CONSTRUCTION OPERATIONS AND SITE UTILIZATION PLAN

CSK-04 ADDENDUM # 1		PBC Onahan 6634 W. Raven Street		2241 S. Wabash Avenue Chicago, Illinois 60616 Phone 312.567.1000 / Fax 312.567.9690	
Project #: 11-0720	Drawn By: AV	Date: 2011/12/29	BauerLatoza STUDIO <small>Architecture Historic Preservation Landscape Architecture Urban Design</small>		
Dwg File: C-1.1	Checked By: HG	© Bauer Latoza Studio, 2011

CPS William J. Onahan Elementary
6634 W. Raven Street
Chicago, IL 60631

ISSUE: ADDENDUM 1
 TITLE: COLUMN SCHEDULE
 REFERENCE: S1.0

SITE PLAN - REVISION

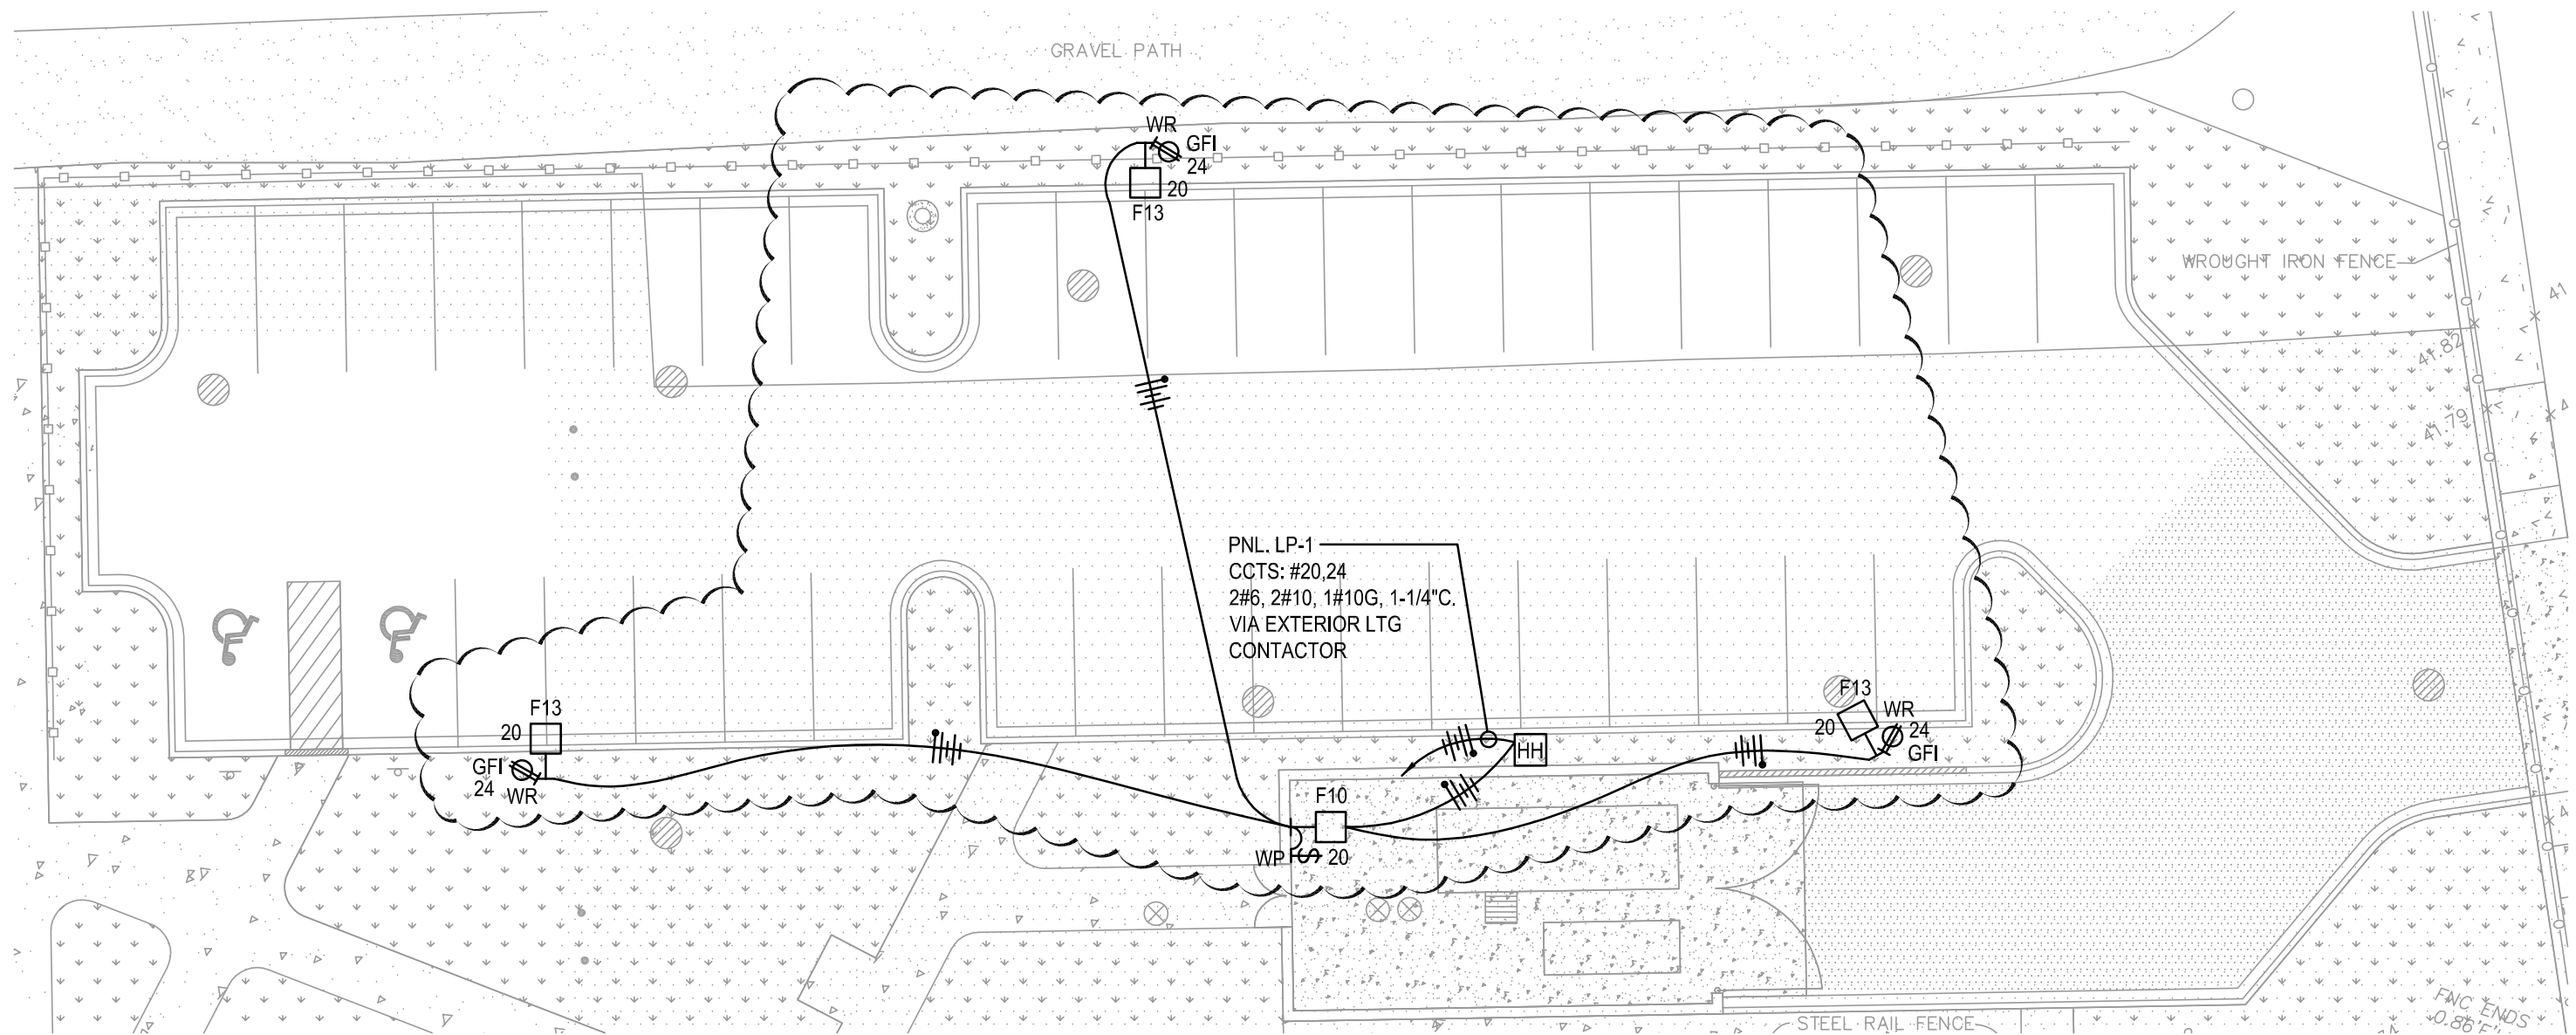
REFER TO SHEET ES.1

PARKING LOT - LIGHTING REVISION

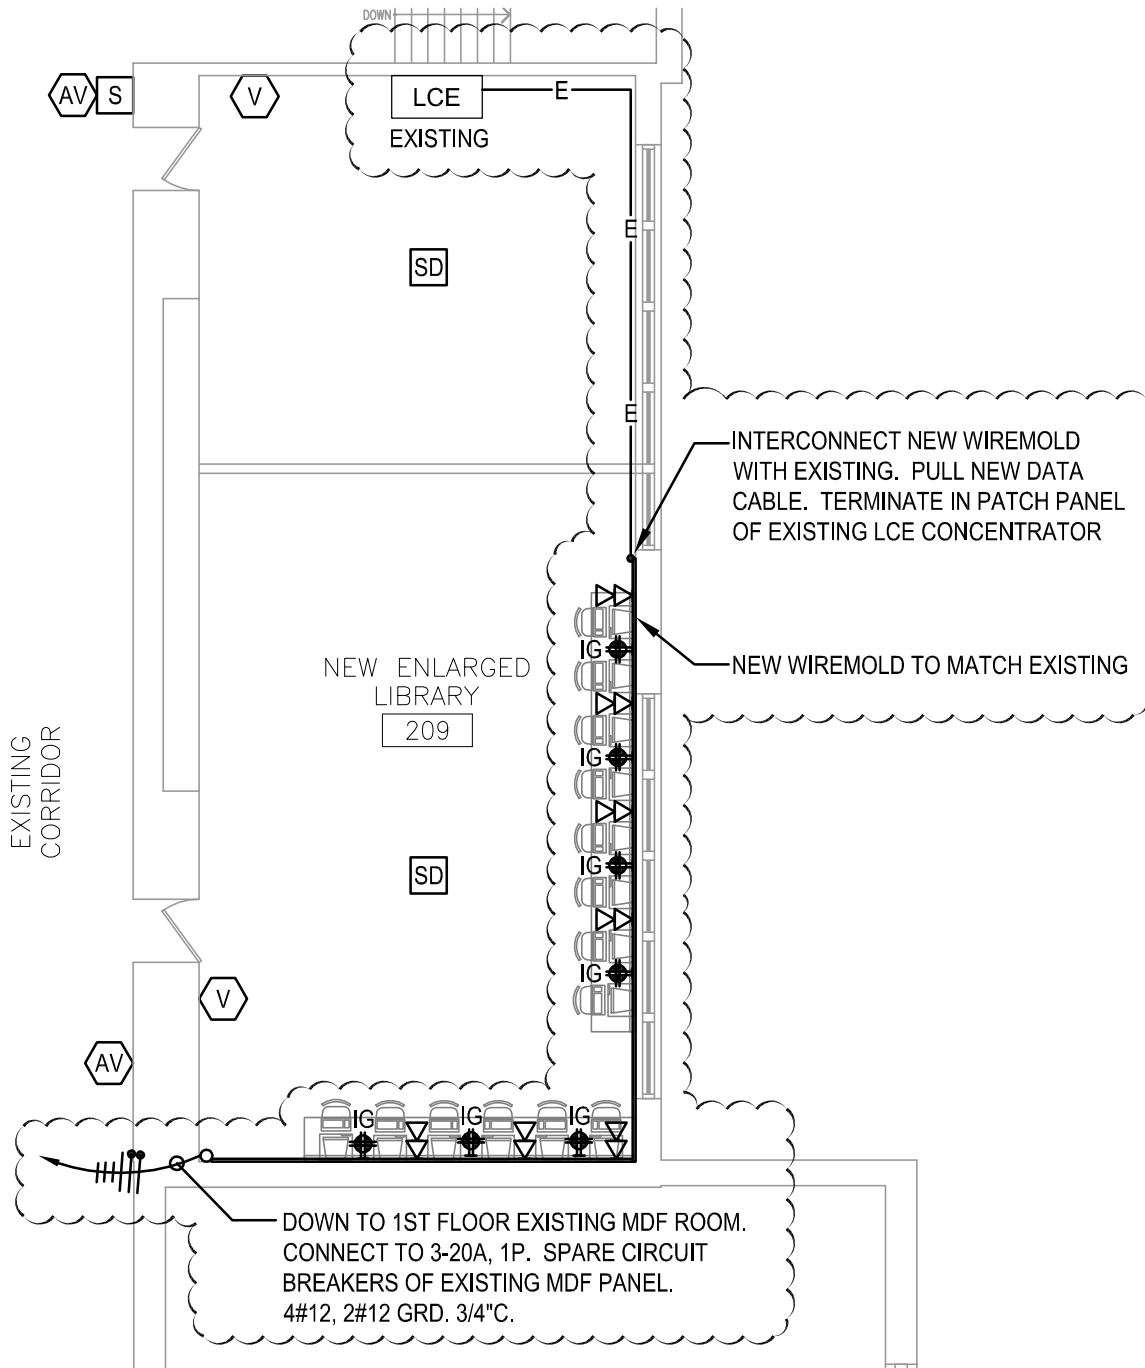
REFER TO SHEETS ES.3 & E8.7 / 2
